*Preliminary Consultation*  
**MONTGOMERY COUNTY HISTORIC PRESERVATION COMMISSION**  
**STAFF REPORT**

<b>Address:</b>	8000 Hampden Lane, Bethesda	<b>Meeting Date:</b>	1/25/2023
<b>Resource:</b>	Contributing Resource (Greenwich Forest Historic District)	<b>Report Date:</b>	1/18/2023
<b>Applicant:</b>	Chuen-Yen Lau & Adam Sherwat	<b>Public Notice:</b>	1/11/2023
<b>Review:</b>	Prelim	<b>Staff:</b>	Dan Bruechert
<b>Proposal:</b>	Accessory Structure Construction

Staff recommends the applicant make revisions based on HPC feedback and return for a HAWP.

**CONCEPT SITE PLAN**  
SCALE: 1"=20'

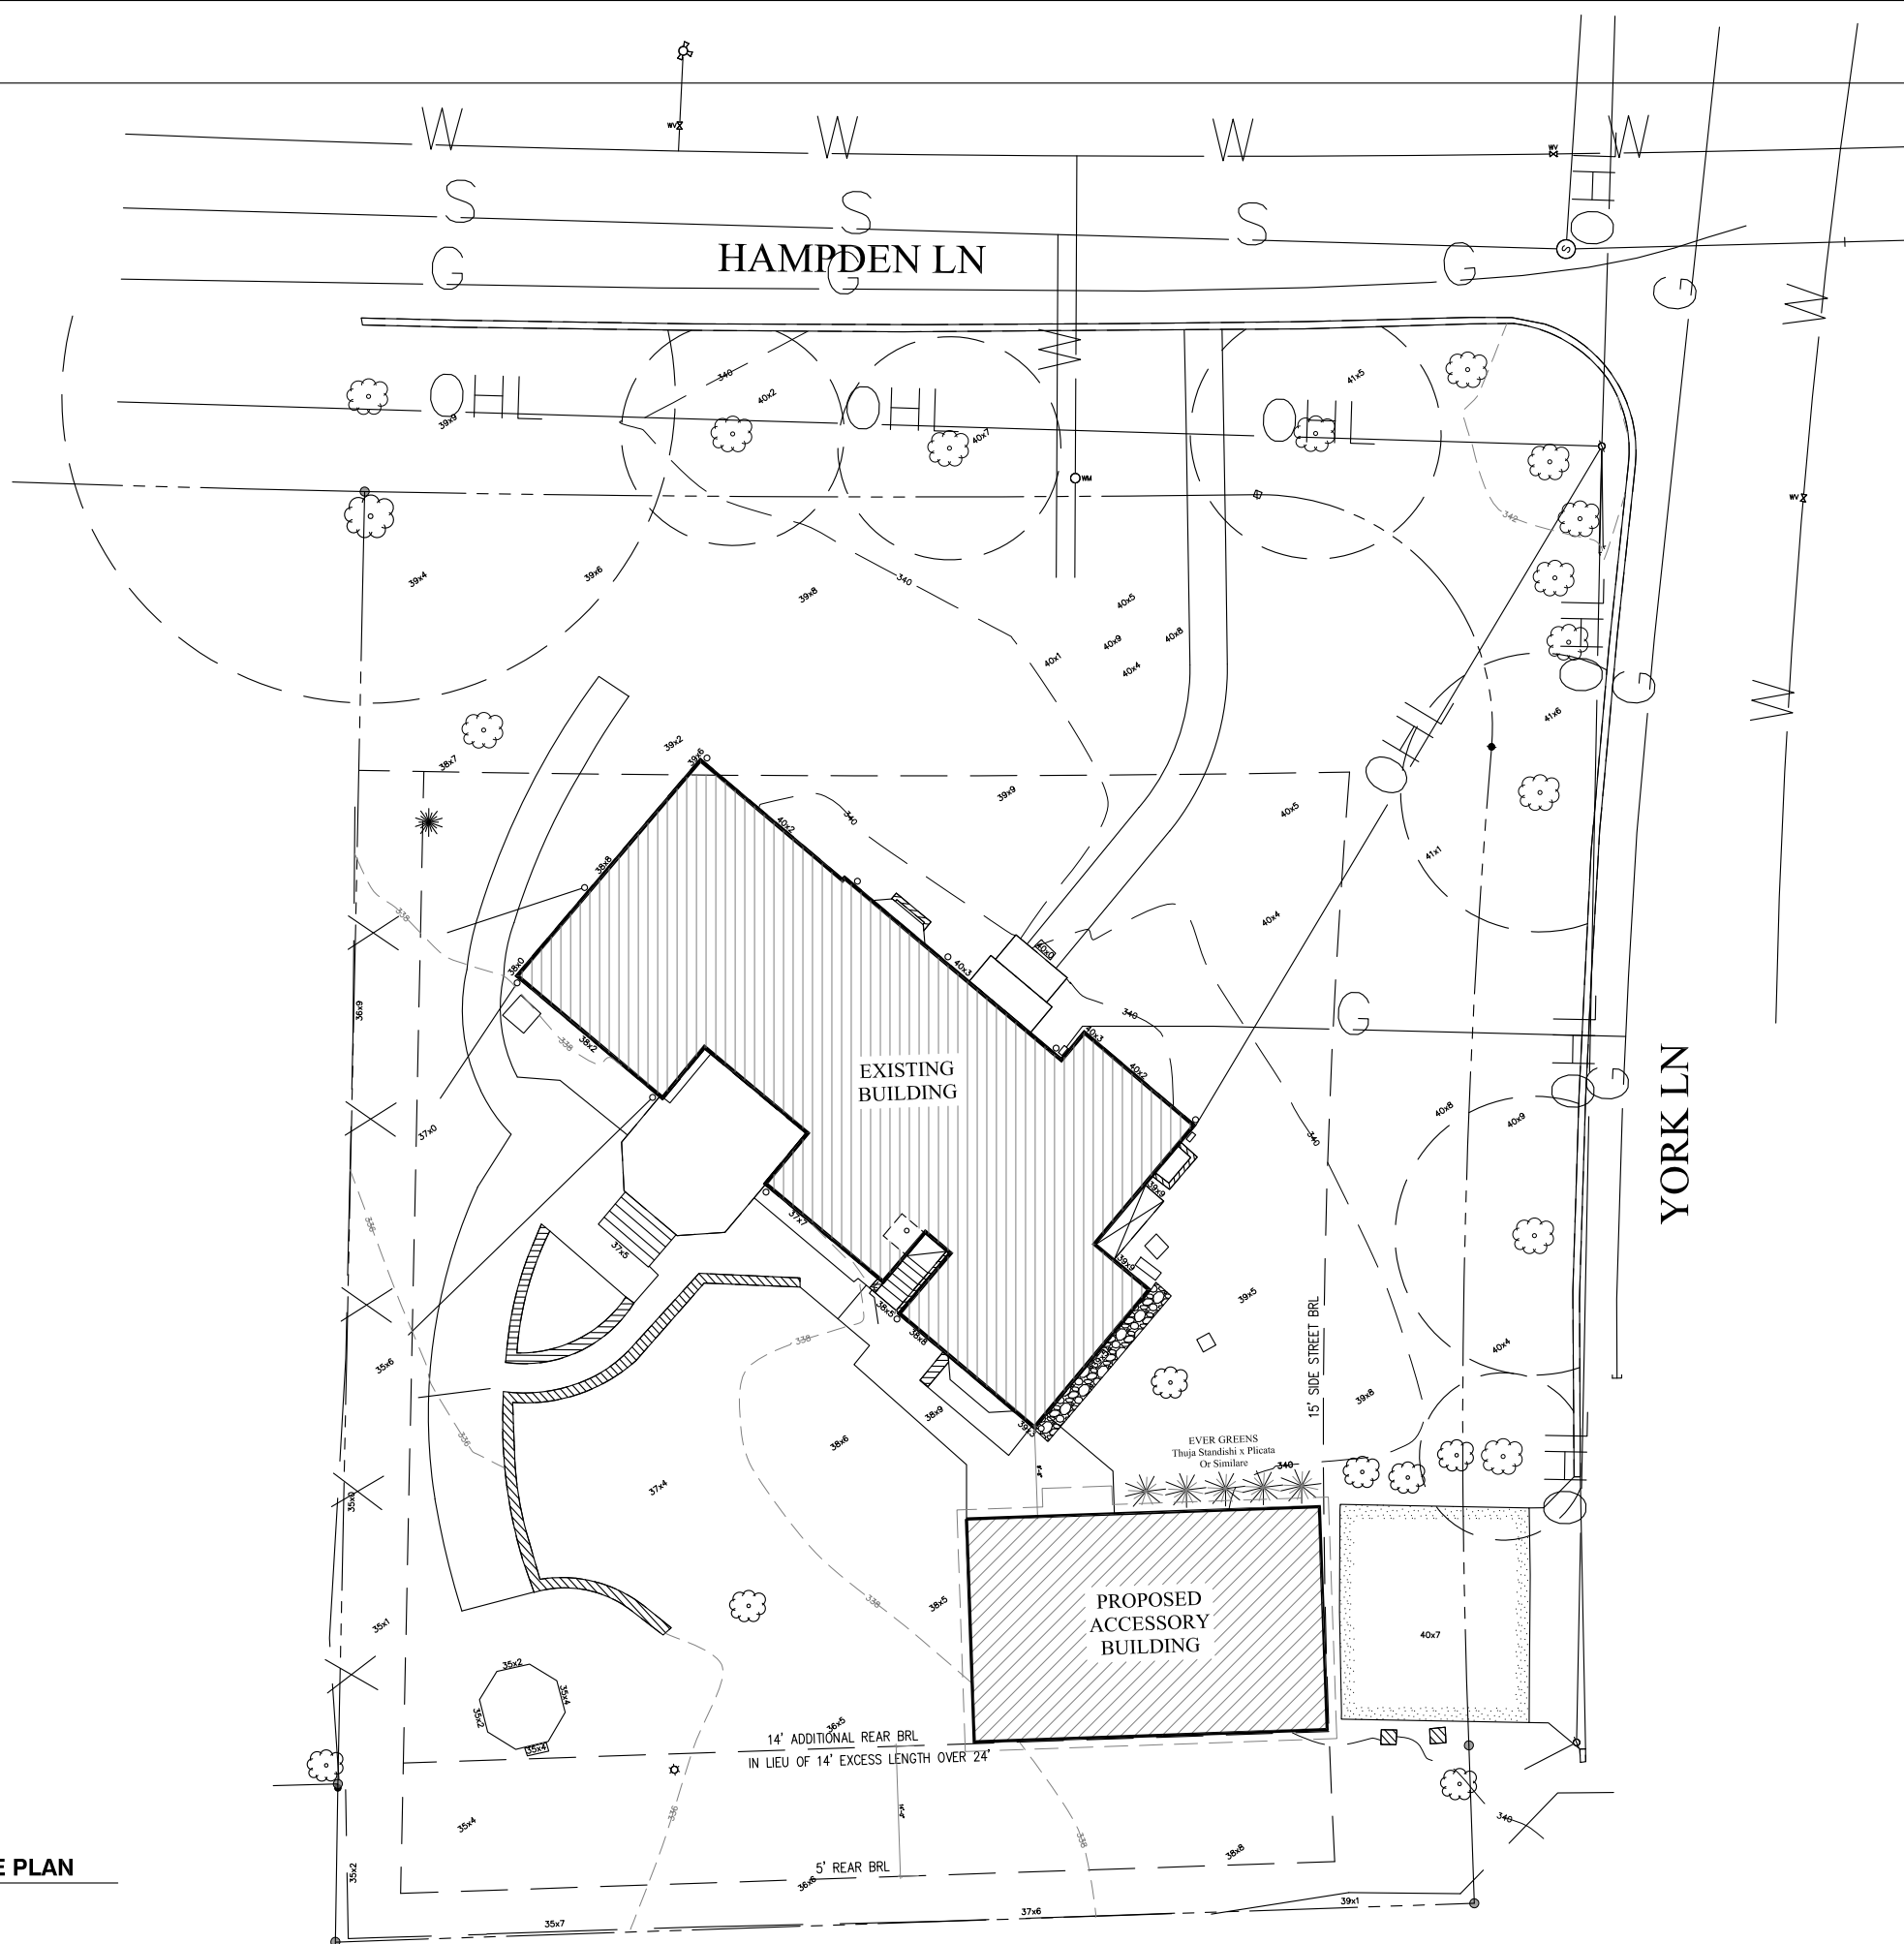
The proposed structure measures 24' × 38' (twenty-four feet wide by thirty-eight feet long), 19' 8" (nineteen feet, eight inches) tall cross gable roof, and will be placed in the southeast corner of the lot, to take advantage of the existing off-street parking pad. To reduce the visual impact the proposed structure will have on the surrounding district, the applicant proposes to plant a vegetative screening on the north side of the building – note: the Greenwich Forest Historic District allows the HPC to consider vegetative screening in evaluating HAWP applications. Materials shown in the plans and renderings are illustrative only, as the focus of this Preliminary Consultation is on the proposed building's placement, size, and massing. Additionally, based on the site plans submitted, one 24" (twenty-four inch) d.b.h. oak tree will be removed to accommodate the new building.

Staff finds that constructing an accessory structure accessible from York Lane is possible. The rear corner of the house is nearly 53’ (fifty-three feet) from the rear property line, which should provide substantial space to undertake this work. In this instance, it is the building footprint that dictates how far from the rear property line the garage has to be (discussion of the building size continues in the next section). Staff’s general concern with this proposal is that the accessory structure will crowd the historic house and detract from the surrounding streetscape. Staff is not opposed to visible garages in the historic district. Ordinarily, garages are constructed to the rear of the property and their visual impact is mitigated either by the distance from the right-of-way, is partially obscured by the house, or both.

Staff finds the proposed garage crowds the historic house and is too close to the street to the point that it detracts from the identified historic character of the district site and surrounding district. As stated in the Master Plan Amendment creating the historic district, “Greenwich Forest’s singular physical character is a neighborhood well known for its extraordinary landscape, finely designed and sited houses, and overall beauty. It is a planned environment that has retained its character from its original conception in the 1920s and for more than seventy years since the initiation of its development...” This is why the primary

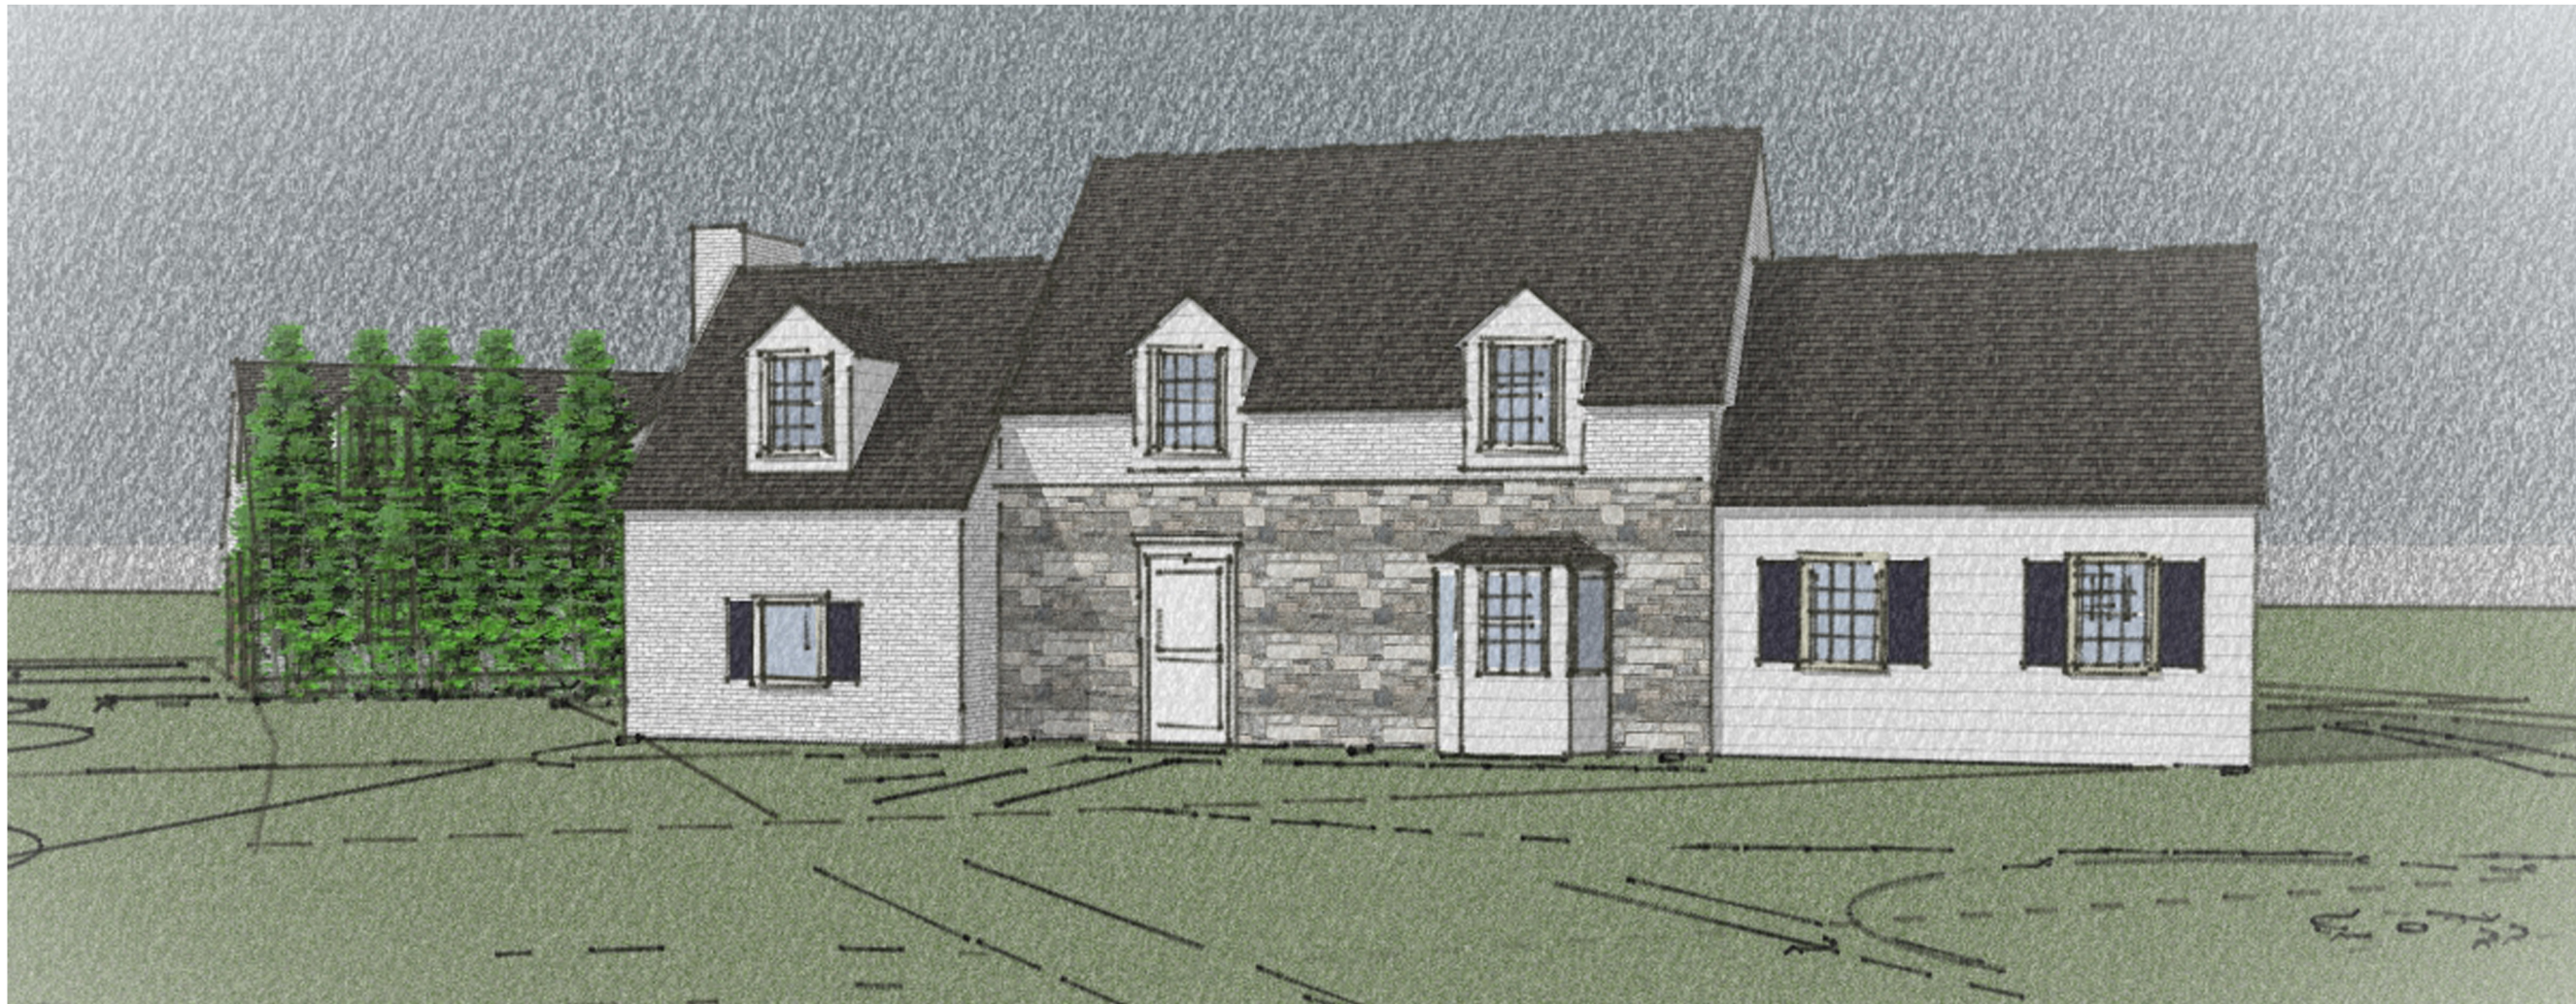
Staff is concerned the proposed roof form creates an appearance that is too large to be compatible with the character of the house and surrounding district. The front wall creates a vertical wall nearly 20' (twenty feet) tall. Staff also finds that the rear cross-gable will create a vertical wall plane, nearly 20' (twenty feet) tall, 10' (ten feet) from the house. Staff finds the garage's massing will encroach on the visual character of the house and detract from the streetscape.
